**NPDES PERMIT FACT SHEET
ADDENDUM**

Application No. PA0012823
 APS ID 985837
 Authorization ID 1317252

Applicant Name	<u>MC Project Company, LLC</u>	Facility Name	<u>Martins Creek Steam Electric Station</u>
Applicant Address	<u>6605 Foul Rift Road</u> <u>Bangor, PA 18013-4857</u>	Facility Address	<u>6605 Foul Rift Road</u> <u>Bangor, PA 18013-4857</u>
Applicant Contact	<u>Dax Fleckenstein</u>	Facility Contact	<u>Dax Fleckenstein</u>
Applicant Phone	<u>(610) 498-6210</u>	Facility Phone	<u>(610) 498-6210</u>
Client ID	<u>347577</u>	Site ID	<u>239923</u>
SIC Code	<u>4911</u>	Municipality	<u>Lower Mount Bethel Township</u>
SIC Description	<u>Trans. & Utilities - Electric Services</u>	County	<u>Northampton</u>
Date Published in PA Bulletin	<u>October 25, 2025</u>	EPA Waived?	<u>No</u>
Comment Period End Date	<u>November 24, 2025</u>	If No, Reason	<u>Major Facility</u>
Purpose of Application	<u>Renewal of NPDES permit.</u>

Figure 3-4: Plan View of Thermal Plume

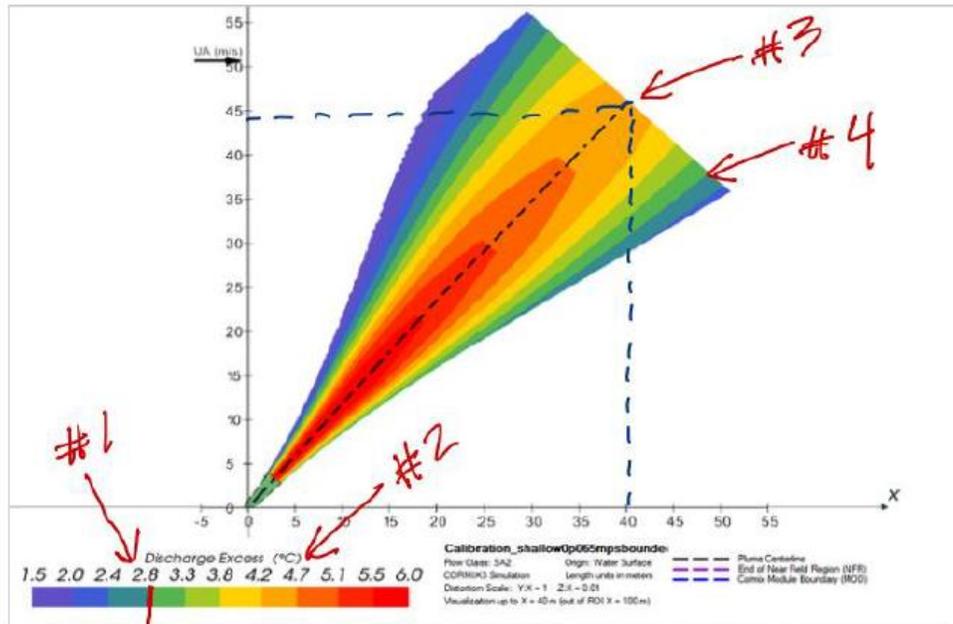
"My comment is based on reviewing documents provided to me by PA DEP through a file review request. In particular my comment is about the content of the Burns McDonnell report "Thermal Compliance Evaluation at the Martins Creek Steam Electric Station" dated 12/8/25. In the introduction (Section 1), in paragraph two, they state the heat dissipation area dimensions (203 feet long and 66 feet wide) that are sufficient to achieve water quality standards. On pdf page 22 of the document is figure 3-4 which I have pasted below. I added some numbers to the figure in red to reference my comments better. I don't have the technical knowledge to understand everything in the entire document but my focus on figure 3-4 is based on the verbiage describing that figure. That verbiage appears to indicate the figure matches the heat dissipation area dimensions stated in the introduction. I therefore assume this figure is an important part of the justification to achieve water quality standards.

Reference #1 in the pasted figure below - I interpret the color chart to show the temperature in degrees Celsius that the discharge causes the river temperature to rise. If that is correct then 5 degrees Fahrenheit would be at the transition from dark green to the middle color green.

Reference #2 in the pasted figure below - The medium orange color is 4.2 to 4.7 Celsius (7.6 to 8.5 Fahrenheit).

Reference #3 in the pasted figure below - I drew dotted lines in blue from the x and y axis to the tip of the end of the center line they show in the plume. A rough calculation of that centerline assuming my lines are somewhat square, I get about 197 feet along the centerline. Which is pretty close to their stated 203 feet along the centerline. So far so good. I used 40 meters as the x distance and 45 meters for the y axis, which makes the hypotenuse about 60 meters, which is about 197 feet. However, the color at the end of that centerline is medium orange, which I read the color chart to be 4.2 to 4.7 Celsius (7.6 to 8.5 Fahrenheit). So, it would appear to me they stopped the figure of the plume before the water dropped below 5 degrees Fahrenheit rise in river temperature.

Reference #4 in the pasted figure below - Wouldn't the true limit of the mixing zone be where the 5 degree Fahrenheit colors converge in the river? The yellows, oranges and light greens should all be enveloped by dark green somewhere in the middle of the river. That is not shown on this figure because the figure is cut off too soon. Therefore, it would seem their stated mixing zone centerline is not long enough."

The referenced diagram appears to depict the method for calculating the maximum cross-section width of the heat dissipation areas using the theoretical 2.78 °C excess heat boundaries from the mixing zone. It's agreed that the diagram doesn't show the entire length of the mixing zone along the center line, however, that doesn't appear to be the intention of Figure 3-4.
